Value Engineering Study  
Report

**KY 536 EXTENSION – 6-352.00**

**VE Number: 202501**

**Report Date: April, 2025**

**Use arch culvert in lieu of bridge at Jerry Wright**

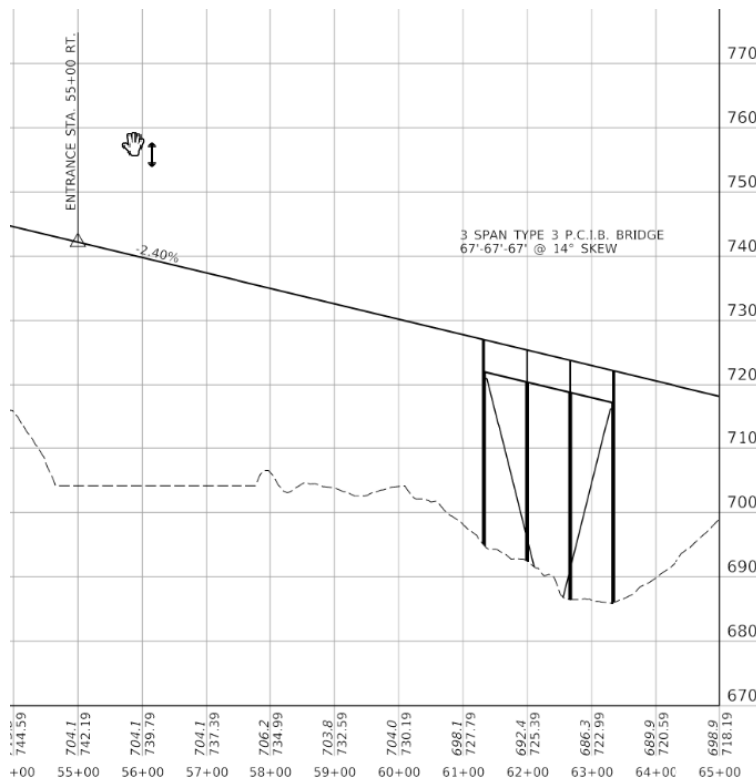
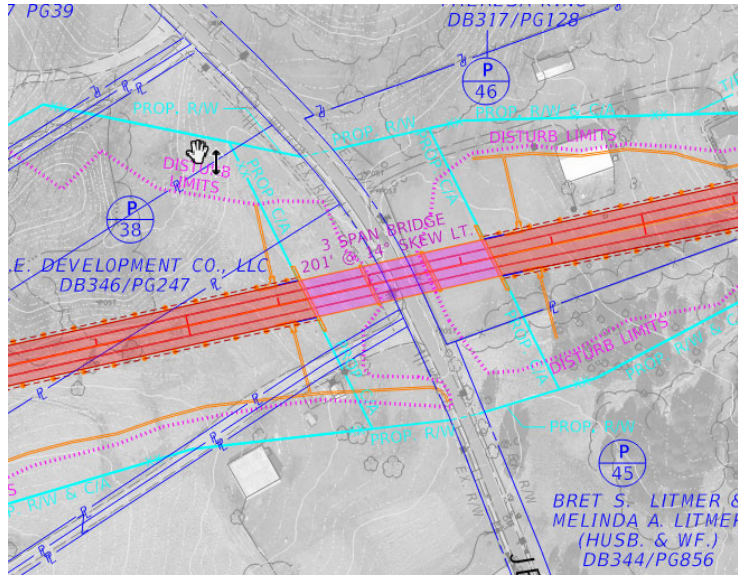
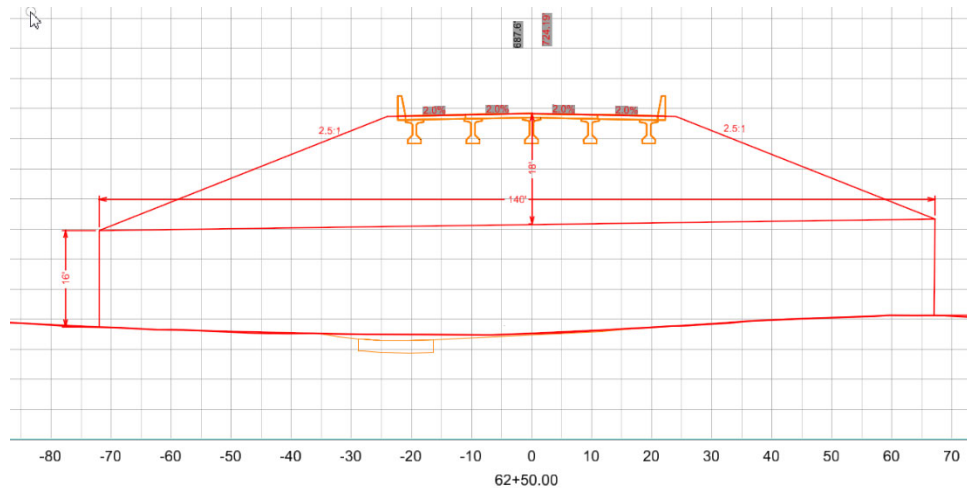
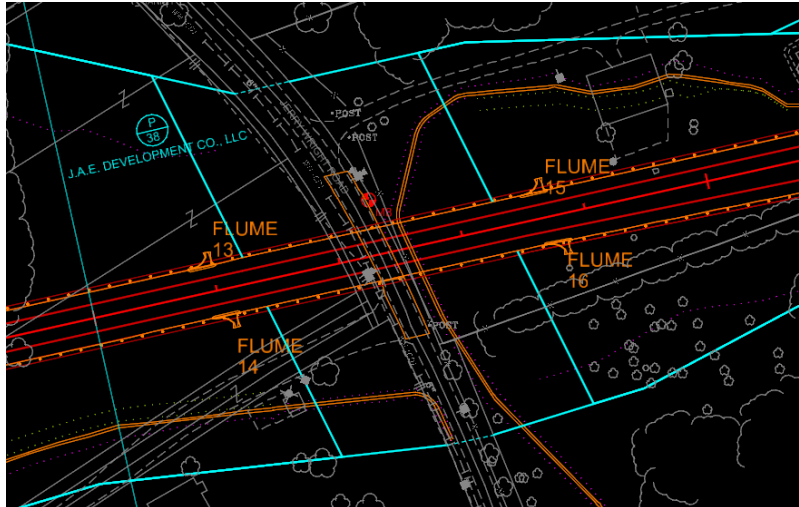
The baseline concept for the KY 536 corridor is to bridge over Jerry Wright Rd with a 201 ft long – 3 span bridge, ranging in height from 35 ft to 40 ft tall and constructed between two fill sections. The baseline concept does not provide access to KY 536 from Jerry Wright Rd but does not cut off use of Jerry Wright Rd.

The alternative could provide a less costly structure to cross Jerry Wright Rd without cutting off local traffic. Additionally, new potential options to better balance/reduce earthwork by providing additional onsite borrow disposal, adjusting KY 536 profile grades, and optimizing vertical curve length and locations.

| <b>Attributes and Rating Rationale</b>   |
|--|
| <b>Mainline Operations</b> – No Change from baseline concept.  |
| <b>Local Operations</b> – No change to the local operations from the baseline concept, although a different structure is proposed, they will operate the same.   |
| <b>Maintainability</b> – Increased maintainability by proposing a smaller and less costly structure to maintain in the future. The alternative would also provide easier access for maintenance and future rehab projects.               |
| <b>Construction Impacts</b> – Increased construction impacts, although the alternative does provide a more easily constructed structure it will introduce additional construction and maintenance of traffic phasing on Jerry Wright Rd. |

| Alt No. | Alternative Title  | Implement Status | Decision Rationale / Comments   |
|---------|--|------------------|---|
| LR-1    | Use arch culvert in lieu of bridge at Jerry Wright               | A                | Redesign required.<br>Historical Note: In 2001, reconstruction of Jerry Wright Rd to provide an at-grade intersection was considered but ultimately not advanced due to its negative effect on the residents along the existing road. |

### Provide intersection at Jerry Wright in lieu of grade separation

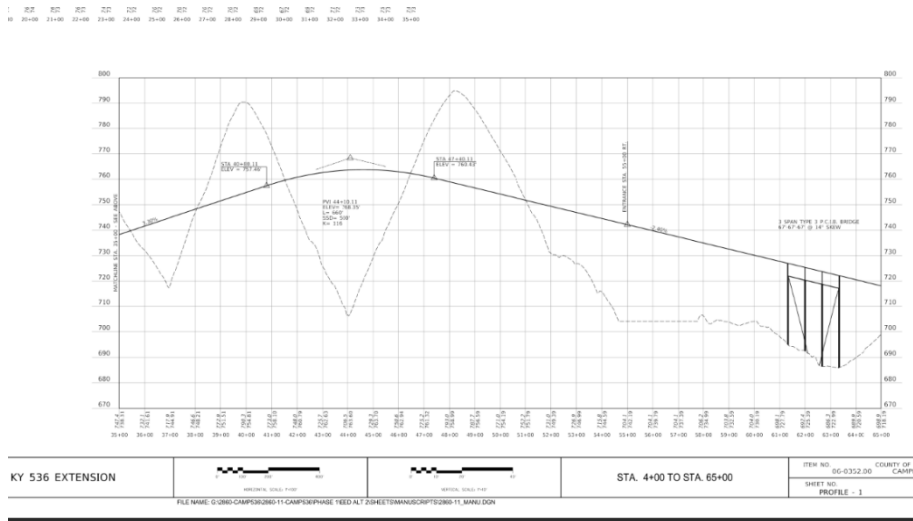
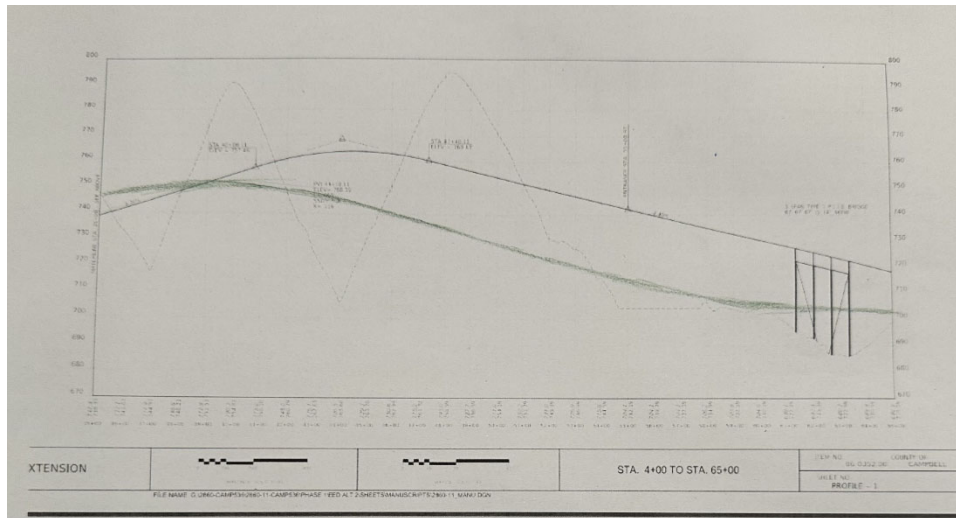
This alternative would align the grades of KY 536 and Jerry Wright Road to provide an at-grade, side street STOP controlled intersection in lieu of grade separation. The concept would propose a combination of lowering the profile of mainline KY 536 at Jerry Wright Rd., as well as raising the profile of Jerry Wright Rd itself.

Embankment/Excavation for proposed profile will net excess material vs baseline and to be placed elsewhere on the project. Additional excavation quantity of 30,000 CU YD assumed.

| Alt No. | Alternative Title  | Implement Status | Decision Rationale / Comments   |
|---------|--|------------------|---|
| LR-2    | Provide intersection at Jerry Wright in lieu of grade separation | R                | Does not provide any savings over recommendation LR-1 when the additional 30,000 cubic yards of excavation is taken into consideration  |

### Use connectors to KY 536 at Persimmon Grove in lieu of bridge for grade separation

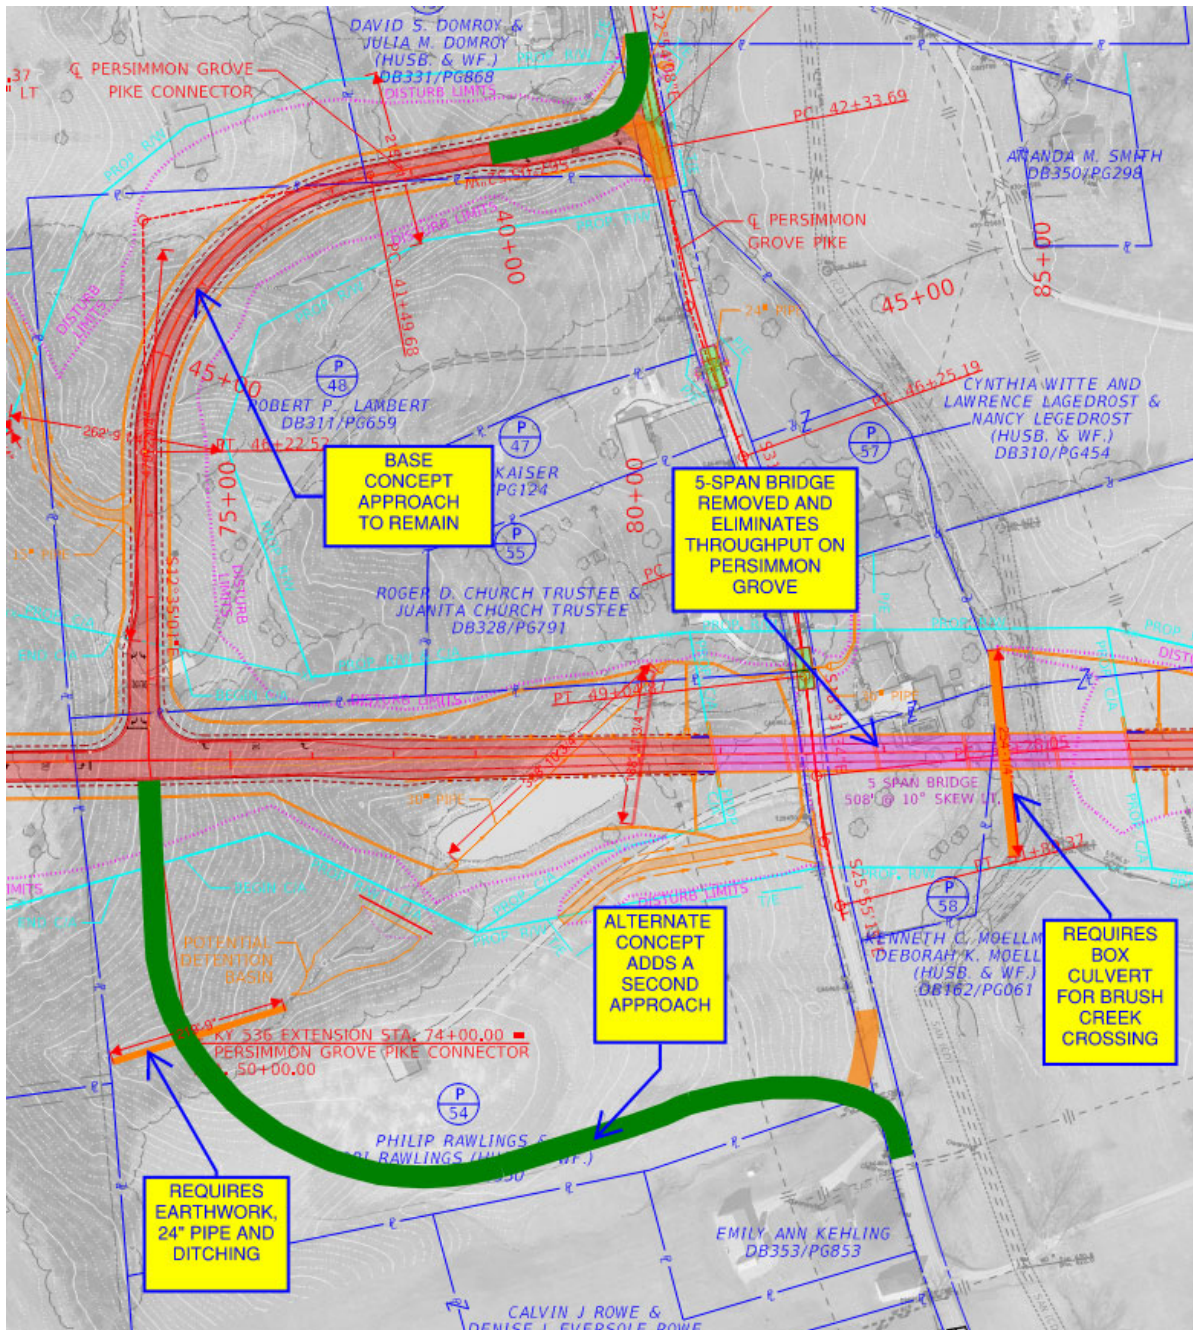
The baseline concept provides a bridge across Persimmon Grove Pike and a connector approach road to provide access to KY 536. The topography requires this structure to be a 508 LF 5-Span bridge and approximately 40' high over Persimmon Grove Pike. This bridge accounts for about 10% of the project's total construction cost, at a cost of over \$6 million.

- Provide a large cost reduction to the project.
- Allows an opportunity to lower the profile across Persimmon Grove Pike to reduce earthwork, if desired. Lowering the mainline profile improves the grades from each approach connection.

| <b>Attributes and Rating Rationale</b>   |
|--|
| <p><b>Construction Impacts</b></p> <p>No change in construction impacts. Traffic will have to be maintained when the closure occurs, but constructing the bridge would also provide periods of closure.</p>                            |
| <p><b>Environmental Impacts</b></p> <p>Additional stream impact at Brush Creek and additional ROW required.</p>  |

Earthwork will mostly be embankment for this alternative so is not considered as additional cost. The baseline concept overall has additional material to waste, and this would provide another location to do so.

| Alt No. | Alternative Title  | Implement Status | Decision Rationale / Comments  |
|---------|--|------------------|--|
| LR-3    | Use connectors to KY-536 at Persimmon Grove in lieu of bridge for grade separation | A                | An acceptable design should be achievable, but undesirable features may be unavoidable. Additional design and survey is required for the south side connection and new drainage structure. The mainline grade change will require redesign of the north connector. Preliminary calculations show a larger culvert opening will be required than was shown in the VE Draft Report. Historical Notes: During Phase 1 design it was found that a south side connection produces more cut and takes more length to tie in than the north side connector. This option also increased stream impacts. In 2005 the project team had a shorter 3-span bridge here with a 25X8 box culvert. In 2013 the project team decided that a longer 5 span bridge was preferred to a bridge and culvert combination because the cost of the 320' RCBC did not provide any savings over shortening the bridge and also increased the stream impact. Later in 2023 the team decided that the 5 span bridge would continue to be advanced and access provided from the mainline to Persimmon Grove Pike with a connector road to the north. |

## Use frontage road or local driveway for Gas Access Road

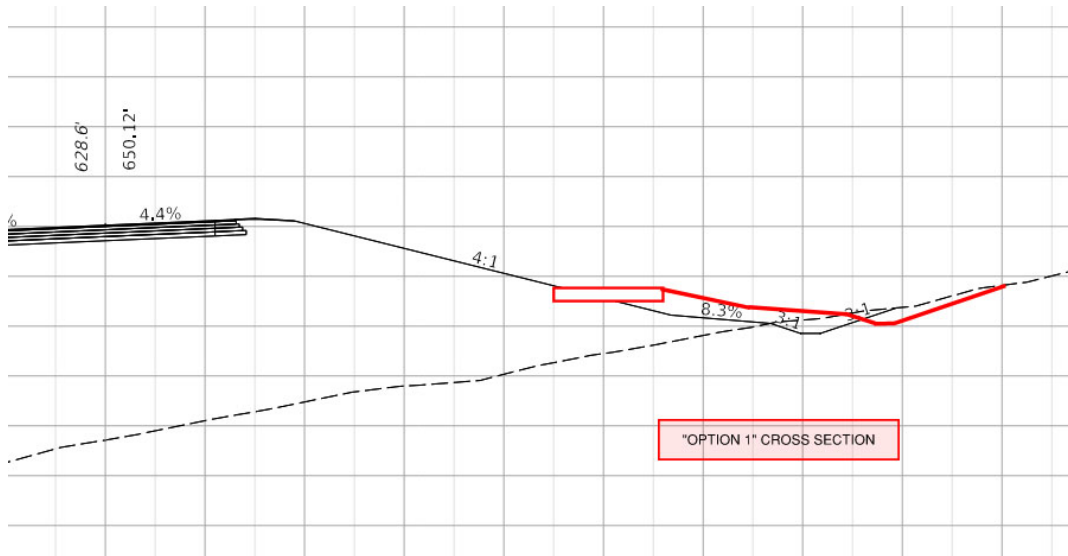
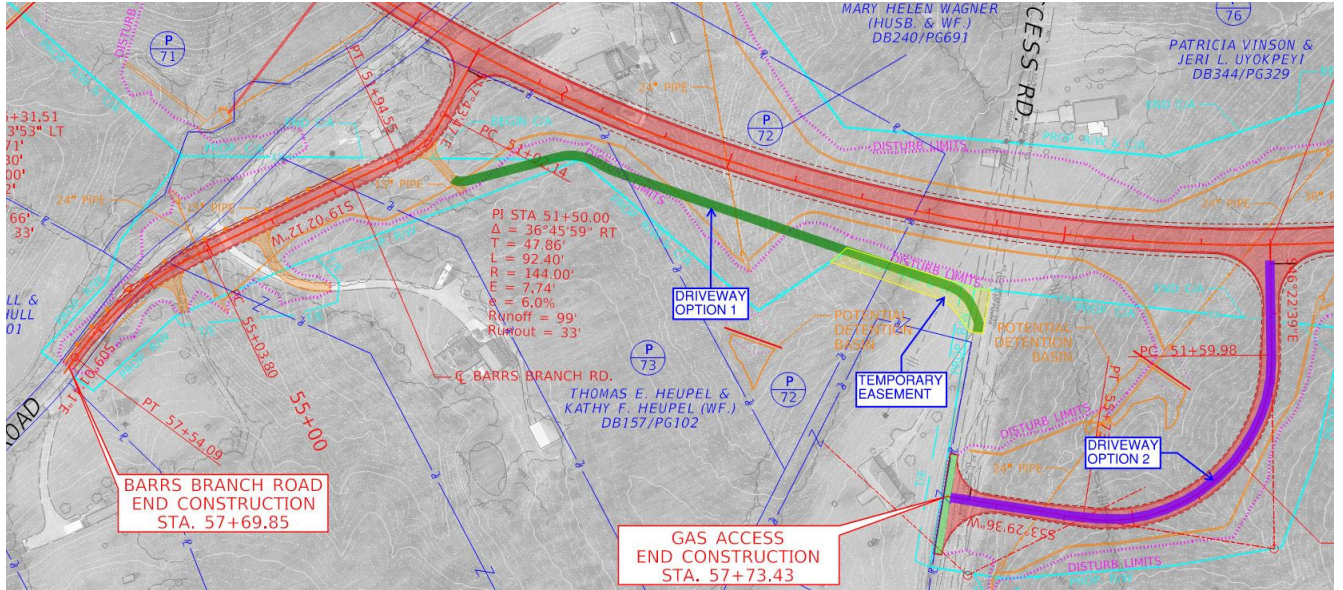
The baseline concept of KY 536 includes approach road connections on the south side at both Barr's Branch Road and Gas Access Road. These approach roads provide 2-11' lanes and a pavement design with 13.75" of asphalt, 5" crushed stone base, and 8" lime stabilized roadbed. Each connection is approximately 770' long. The approaches are stop controlled at KY 536 and the through traffic on the mainline does not stop. The approaches are spaced at 1200', which is the project goal for minimum access spacing.

| Attributes and Rating Rationale   |
|---|
| <b>Mainline Operations</b><br>Increases for "Option 1" since a conflict point on mainline is removed. No change in mainline operations for "Option 2" as both access points are as in baseline concept. |
| <b>Construction Impacts</b><br>Little or no change to construction; However, reduced paving operations.   |

\*Option 2 will be used for cost comparison since it will provide more construction cost savings than Option 1.

| Alt No. | Alternative Title  | Implement Status | Decision Rationale / Comments  |
|---------|--|------------------|--|
| LR-4    | Use frontage road or local driveway for Gas Access Road                            | R                | With the additional right of way cost and the future maintenance this recommendation does not provide any savings and is therefore rejected.   |

### Use signalized intersection at KY-9 in lieu of MUTs

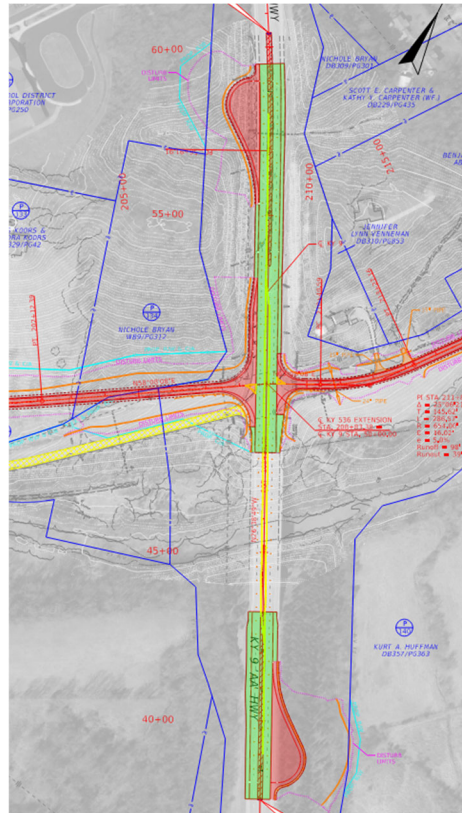
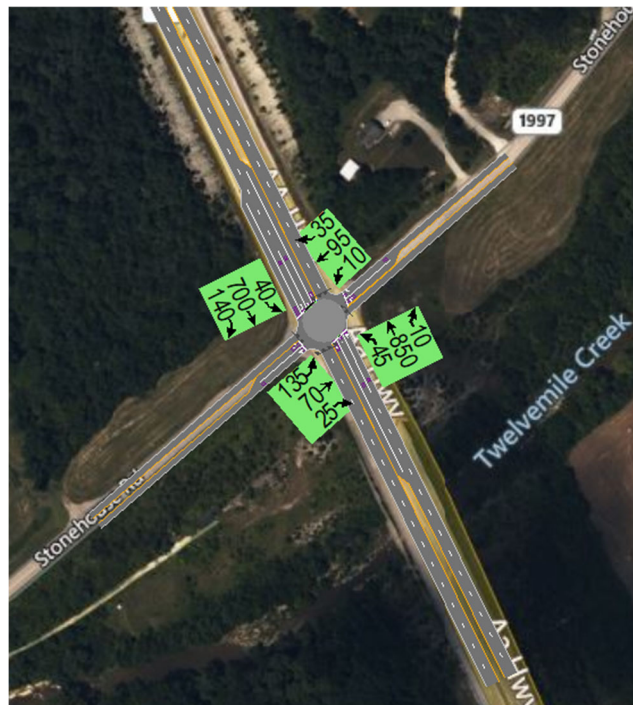
Replace the MUT intersection with a standard signalized intersection. Accommodate turning movements and remove U-turn loons.
